RAC Blackout Investigation Review

Prepared for
The Regulatory Authority of Curacao

Written by
ANTOINE Olivier
olivier.antoine@engie.com

In the framework of
WBS SPO22546

Figure 1: Overview of implementation status of new protection philosophy

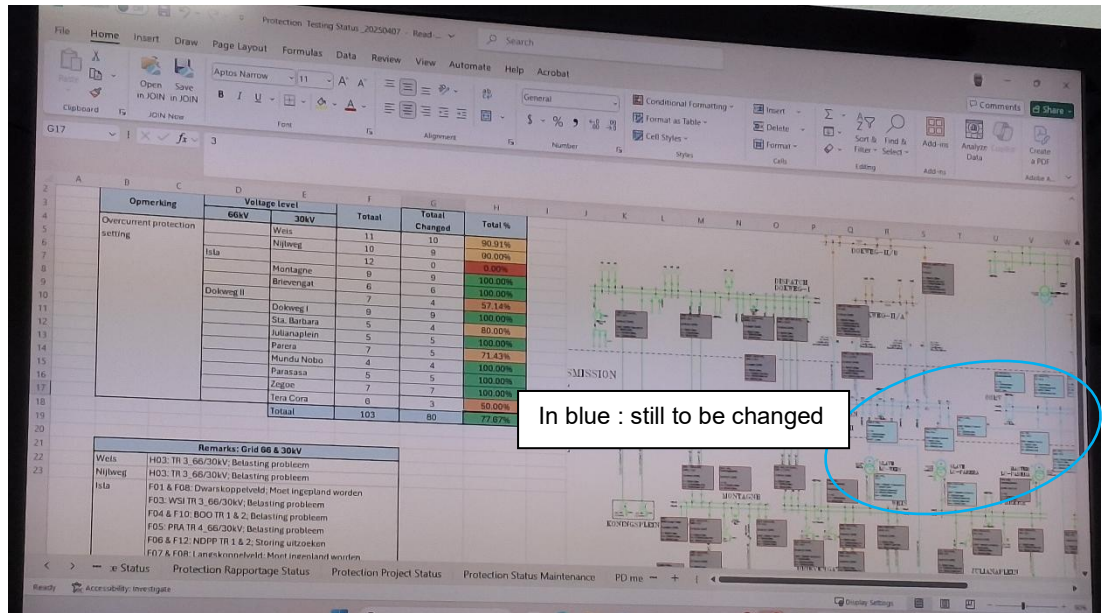
In terms of implementation, it was also recommended to begin with the 12 and 30kV levels before moving to the 66kV, which has been done by Aqualectra. Until the full implementation is completed, there remains a temporary risk of non-selectivity in the event of a 66 kV cable failure and potential malfunction of the differential relays. Aqualectra considers this risk to be acceptable for the time being.

It must also be noted that the follow-up of protection settings change is done in an Excel sheet. It is considered that the use of a centralized database with versioning is beneficial and less prone to errors. It was confirmed by Aqualectra that the implementation in a centralized databased software “StationWare” is ongoing, which when implemented will reduce the risk of error.

- Review of the protection settings every 2 years; test each relay annually.
- Data management: settings are currently in Excel, this is prone to errors unless very carefully handled. The StationWare software was mentioned several times with, recently confirmed, concrete plans to migrate to Stationware for centralized management. The use of softwares like StationWare is good practice and would facilitate tracking settings changes and reduce the risk of errors. As of May 2026, StationWare has been procured and is currently being populated with the required data (during the implementation of the updated protection settings).

- Aqualectra could not commit to a full implementation date because dependent on cable work and outage planning on the 66kV grid. It was mentioned several times that the work to make the 66kV Isla – Dokweg can take some time, and is a pre-requisite. This work was recommended in a "Risk Assessment"³ study done by DNV A best estimation for 100% completion could be around 2027.

Figure 2: Generator capability curve and illustration of recommended testing for limiters⁴. The under-excitation protection is also shown (for illustrative purpose only, this is not based on real settings)

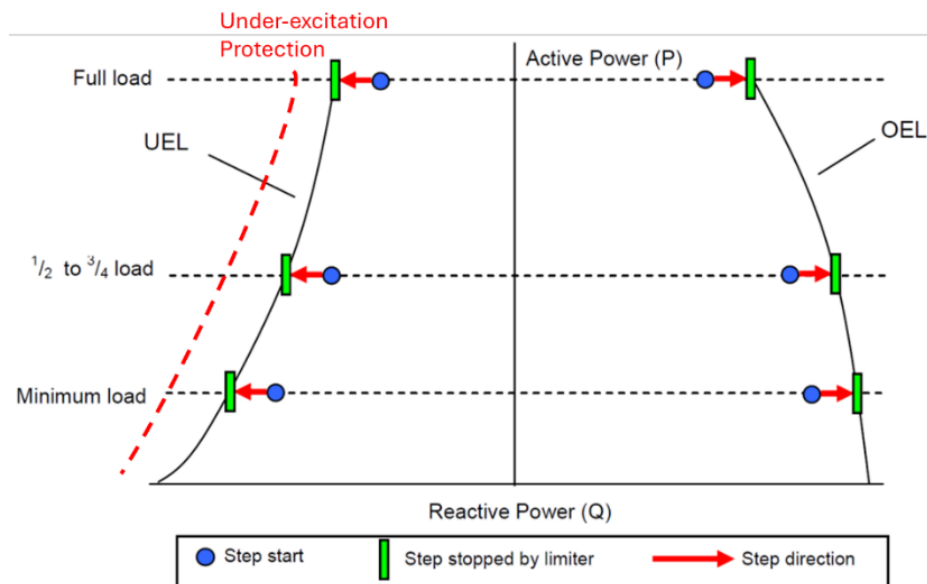
The normal operating modes for units are now droop control, according to the recommendations. There was however no evidence of work performed to verify coordination of UEL and under-excitation protection, but recent discussions on this topic took place between Aqualectra and Wärtsilä in January 2026.

- Coordination between UEL and generator protections to avoid units tripping. As first step, a discussion on UEL settings between Aqualectra and Wärtsilä took place. In addition, it is highly recommended to monitor UEL and protections' logs, and test the coordination of the limiters and protections (similarly to what is proposed by AEMO⁷ in Australia). It also outlines the need to model excitation limiters and generator protections in PowerFactory when performing security analysis.
- Finalize the implementation of the protection philosophy on the 66kV
- Considering to define clear requirements on withstand capabilities for existing and new generating units (including inverter-based assets such as wind, solar and BESS)
- Continue to perform regularly (e.g. yearly) protection coordination studies, as well as security analysis.
